# City of Stevenson

## January 2024 Planning Commission Meeting - RESCHEDULED

**6. Shoreline Permit Request:** (SHOR2023-01 Rock Cove Hospitality)

Figure 1  
 EXISTING CONDITIONS  
 Rock Cove Addendum  
 FDM Development  
 City of Stevenson, Skamania County, Washington  
 Section 1, Township 2N, Range 7E, W.M.

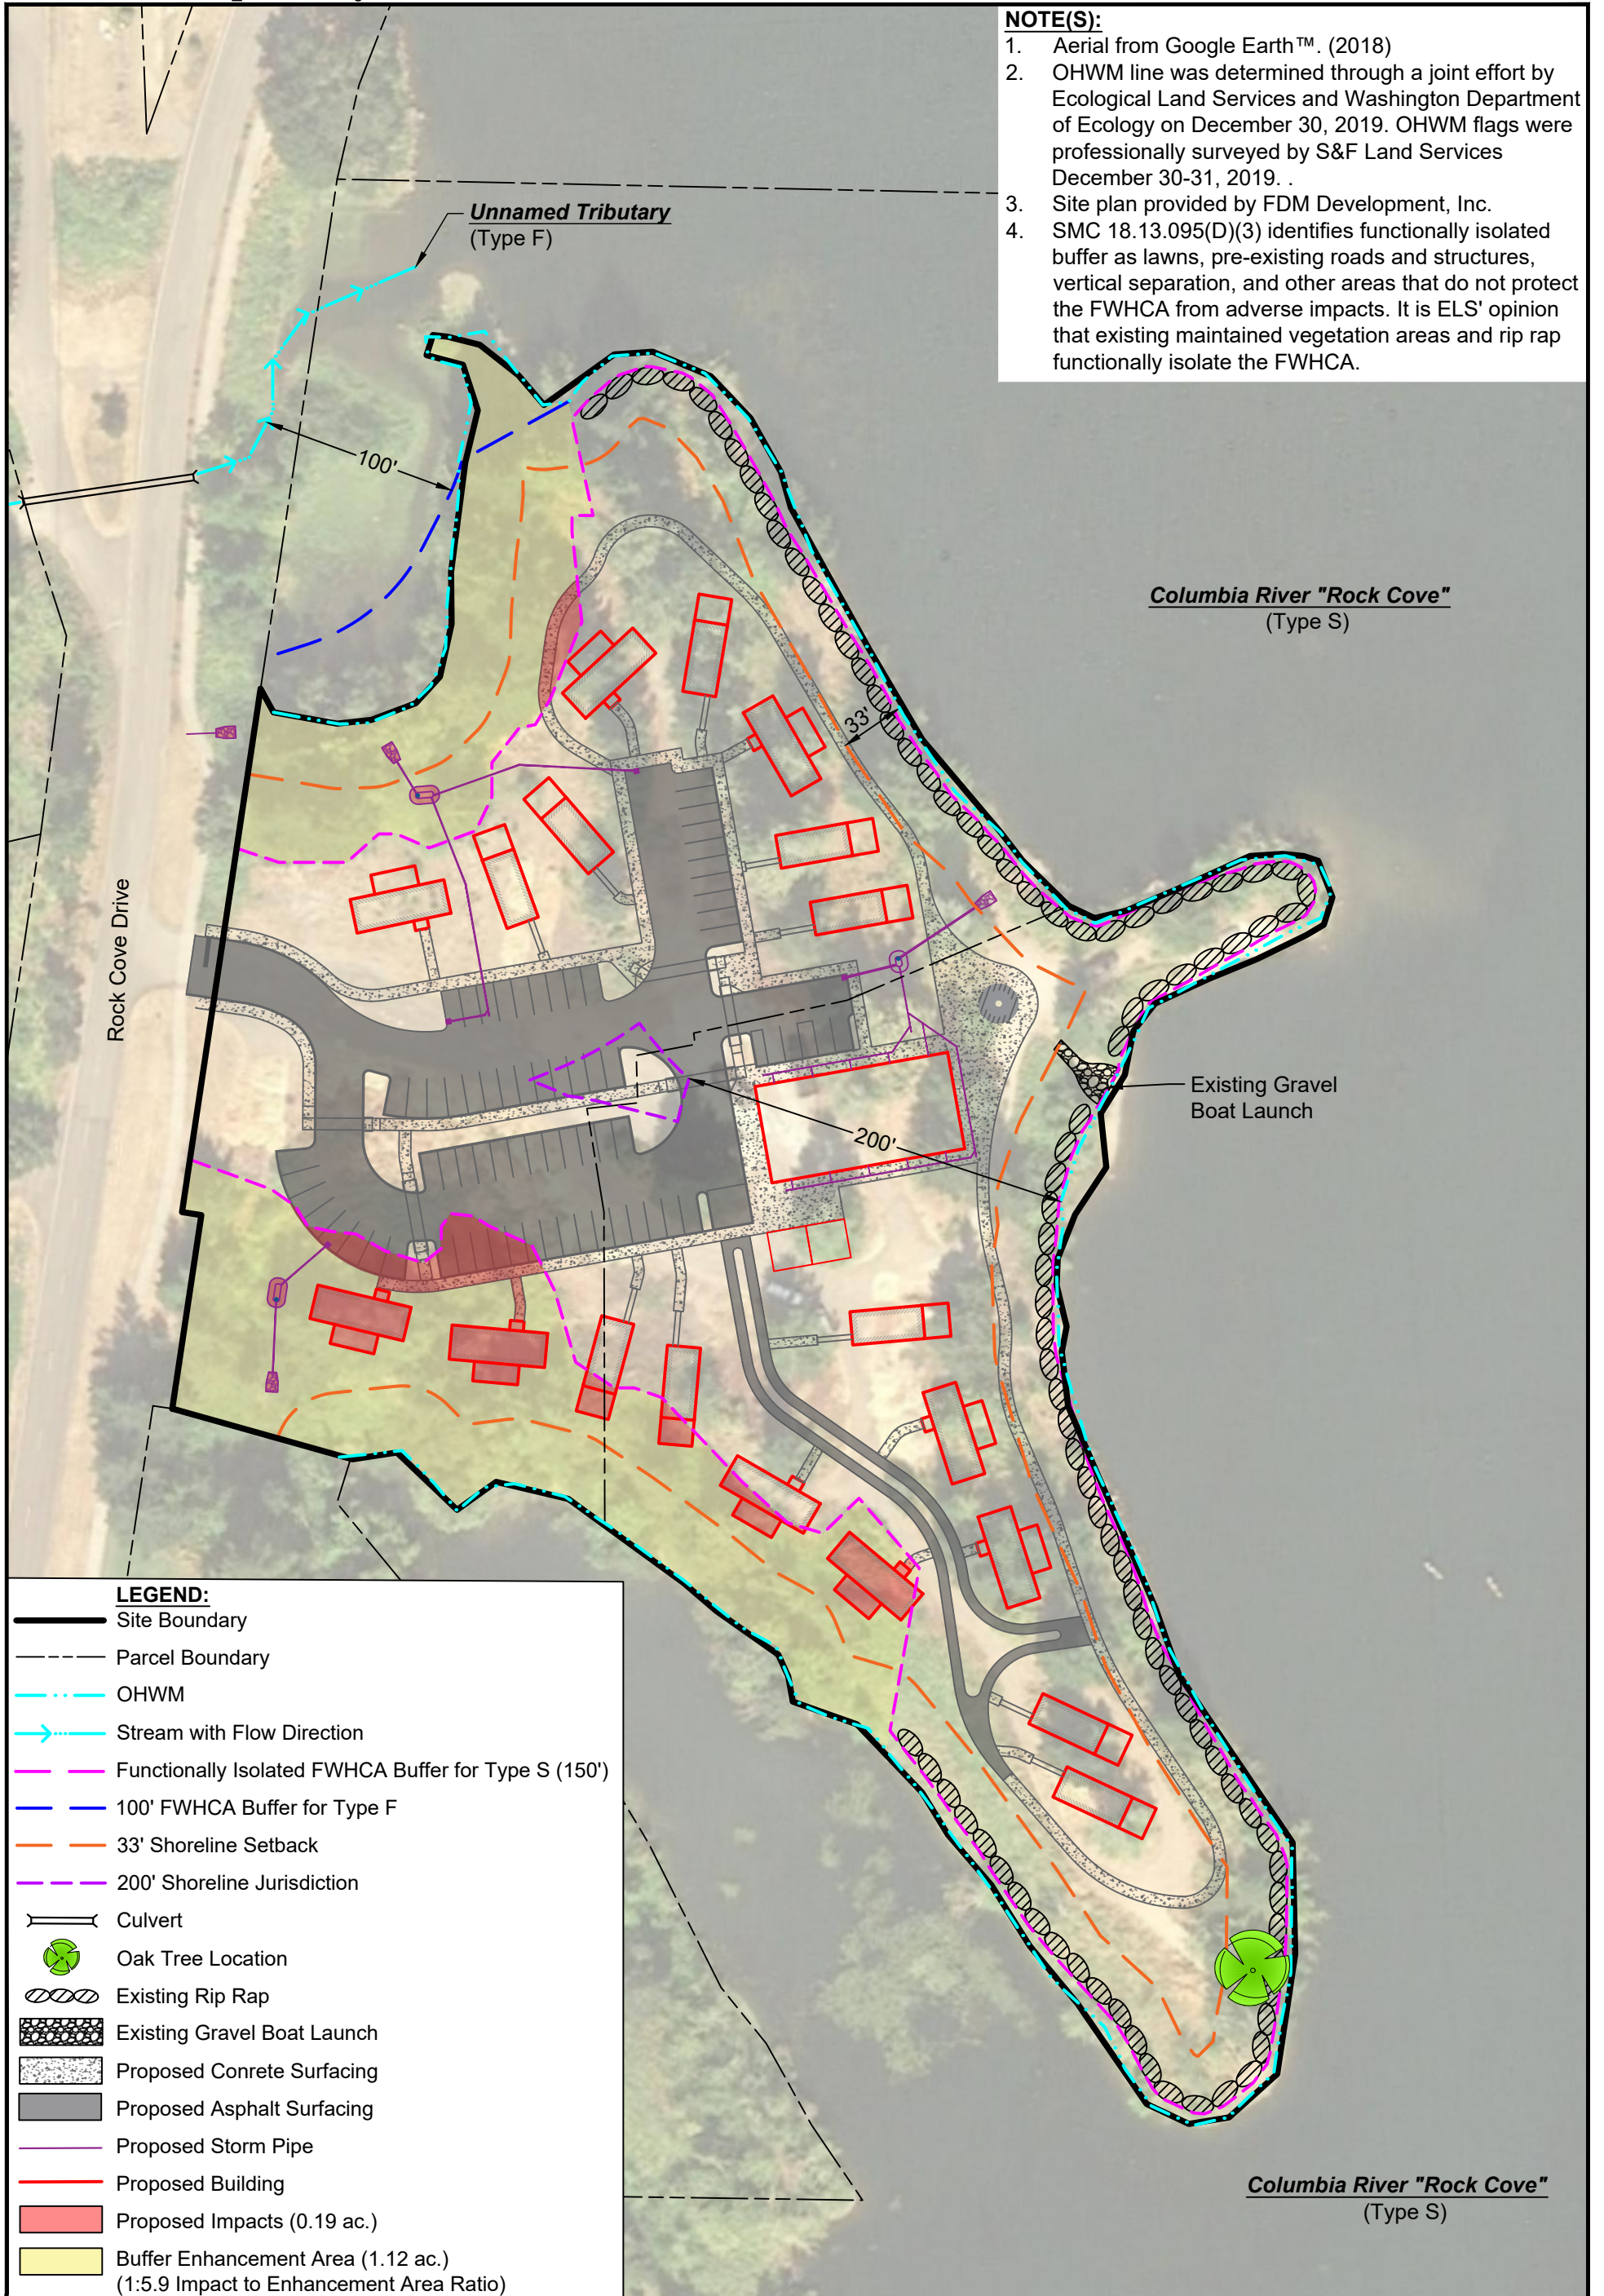
- *Ecology does not think the maintained vegetation areas shown in Figure 1 should qualify as functional isolation.*

Figure 1  
 EXISTING CONDITIONS  
 Rock Cove Addendum  
 FDM Development  
 City of Stevenson, Skamania County, Washington  
 Section 1, Township 2N, Range 7E, W.M.

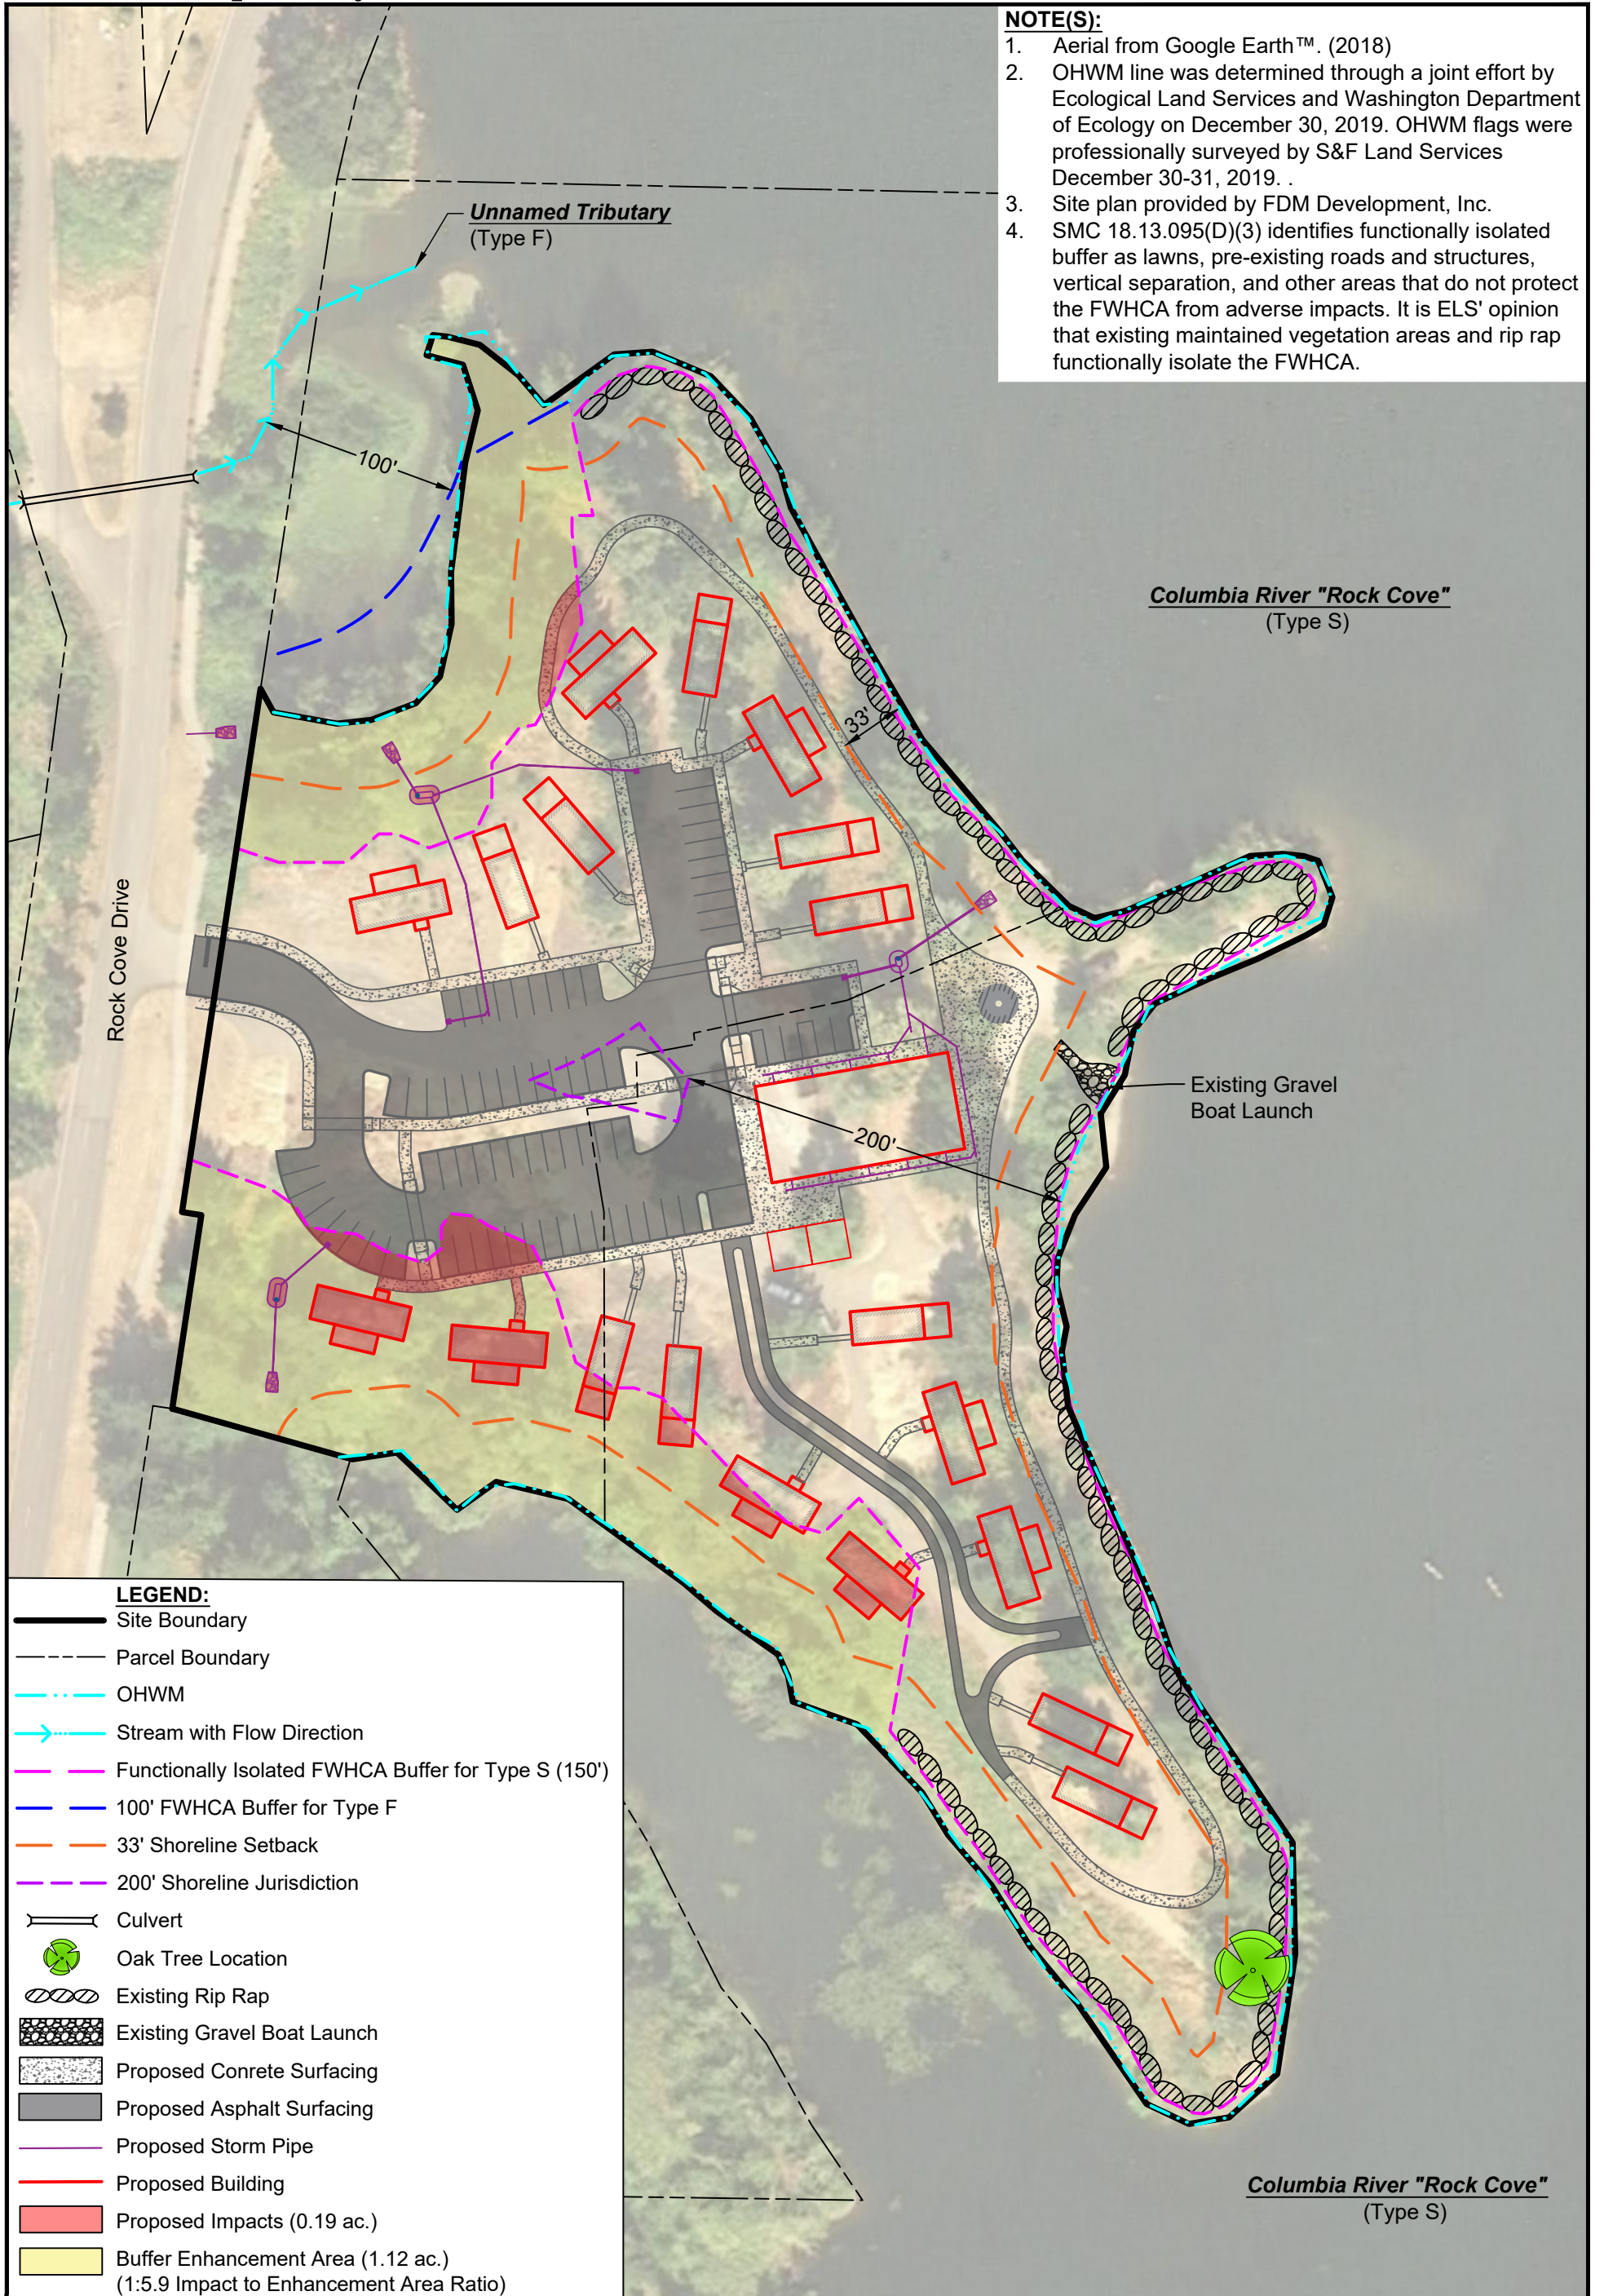
- *Ecology does not think the maintained vegetation areas shown in Figure 1 should qualify as functional isolation.*
